December 2020  
FL866A  
NHTSA #20V-660  
Transport Canada #2020-513

## Subject: Steer Axle Spindle Nut Snap Rings

**Models Affected: Specific Model Year 2020-2021 Freightliner 108SD, 114SD, Business Class M2, Cascadia; and Western Star 4700, 4900, and 5700 model vehicles manufactured June 1, 2020, through September 9, 2020.**

**Fig. 1, Top Snap Ring Tab Incorrectly Installed**

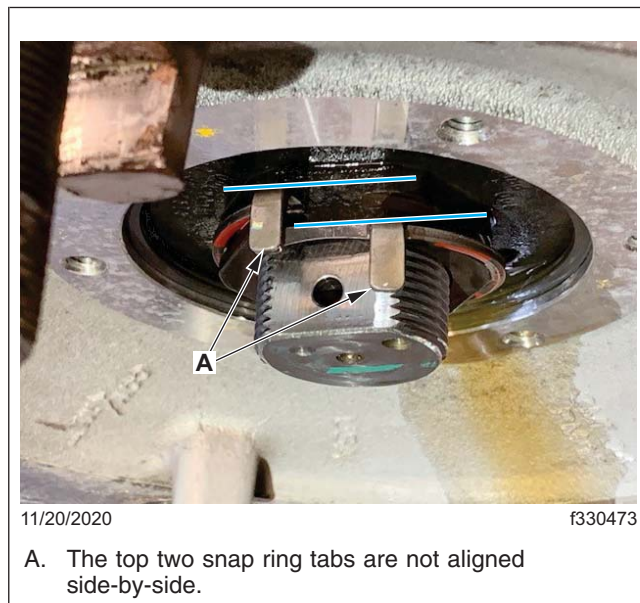
On certain vehicles, the steer axle spindle nut snap ring may not be fully engaged. If the snap ring becomes dislodged, it may not prevent the spindle nut from backing-off causing the hub to loosen and potentially cause a wheel-off condition, increasing the risk of a motor vehicle crash or injury.

7. Confirm the snap ring is properly seated in the spindle nut groove. If the snap ring looks like [Fig. 1](#) or [Fig. 3](#), ref. A, install the snap ring correctly in the grooves.
8. Confirm the locking tab is fully installed in the spindle nut locking hole.  
If the snap ring looks like [Fig. 4](#), go to step 9.  
If the snap ring looks like [Fig. 5](#), go to step 10.

The top two snap ring tabs should be in line and close together. The lower tab should be fully installed in the locking hole in the spindle nut.
